# Western Reactive Transfer Interface Definition Change

- Definition change is due to Network project n4682.
  - Adds new Vinco substation between Conemaugh and Hunterstown.
  - Definition will be effective when the new substation is energized (est. 10/16/18).

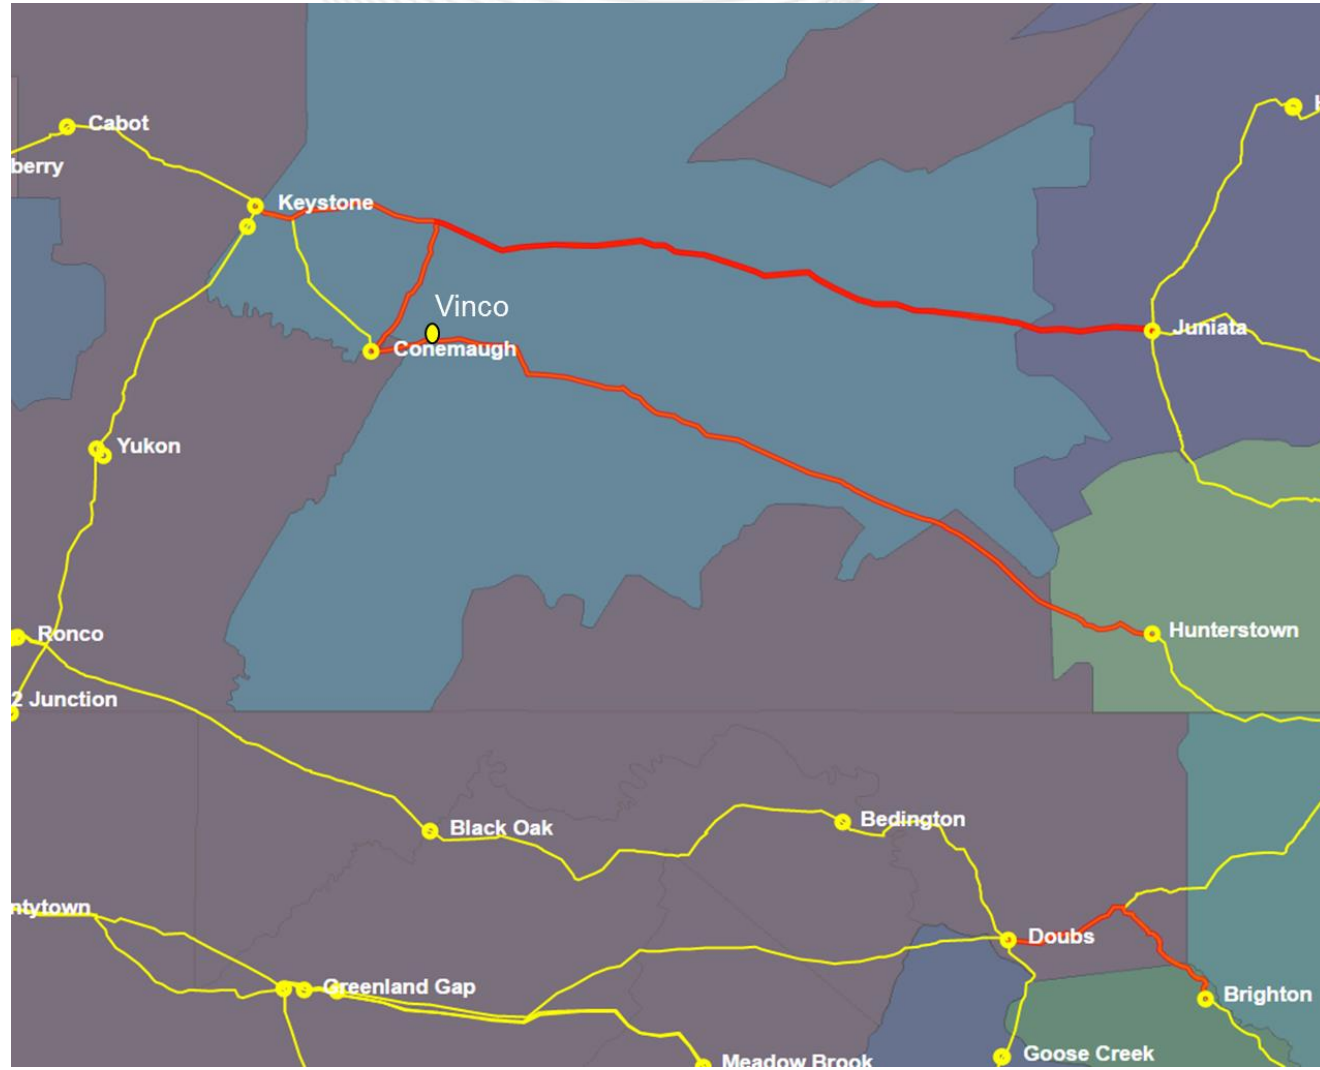
- **Current Definition (from-to)**
  - 5004 Keystone – Juniata 500 kV line
  - 5005 Conemaugh – Juniata 500 kV line
  - 5006 Conemaugh – Hunterstown 500 kV line
  - 5055 / 522 Doubs – Brighton 500 kV line
- **New Definition (from-to)**
  - 5004 Keystone – Juniata 500 kV line
  - 5005 Conemaugh – Juniata 500 kV line
  - 5068 Vinco – Hunterstown 500 kV line
  - 5055 / 522 Doubs – Brighton 500 kV line

- Minimal Impact since the new Vinco substation is close to Conemaugh.
- Manual 03: Transmission Operations will be updated with new definition
  - Interface will remain as an IROL in Manual-37.
- Posted Information:
  - <http://www.pjm.com/markets-and-operations/etools/oasis/system-information.aspx>
